V2500-A5 SERIES PROPULSION SYSTEM NON-MODIFICATION SERVICE BULLETIN

V2500-ENG-73-0233

<u>ENGINE - FUEL AND CONTROL - CONTROL, ELECTRONIC ENGINE (EEC) - REPLACEMENT OF BURNER</u> PRESSURE (PB) SENSORS ON A SPECIFIC EEC POPULATION

ENGINE FUEL AND CONTROL - EEC150-40 - REPLACE SUSPECT PB PRESSURE SENSORS

LOCATION OF THE ELECTRONIC ENGINE CONTROL 73-22-34 FIGURE 1

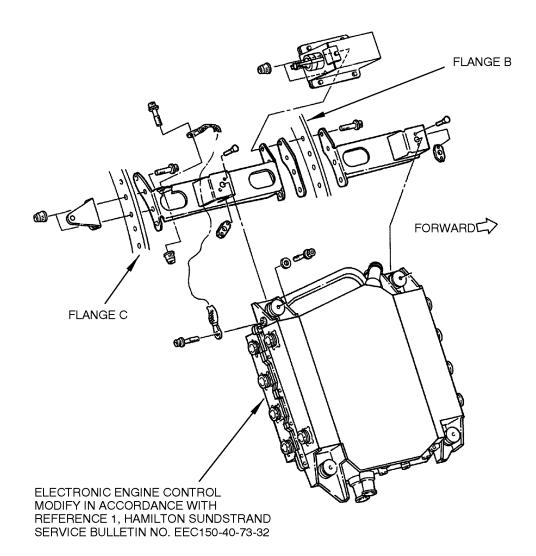
- (1) Modify your Electronic Engine Control (EEC) in accordance with Reference 1, Hamilton Sundstrand Service Bulletin No. EEC150-40-73-32. See Figure 1 for the location of the EEC.
- (2) Recording Instructions
 - (a) A record of accomplishment is required.
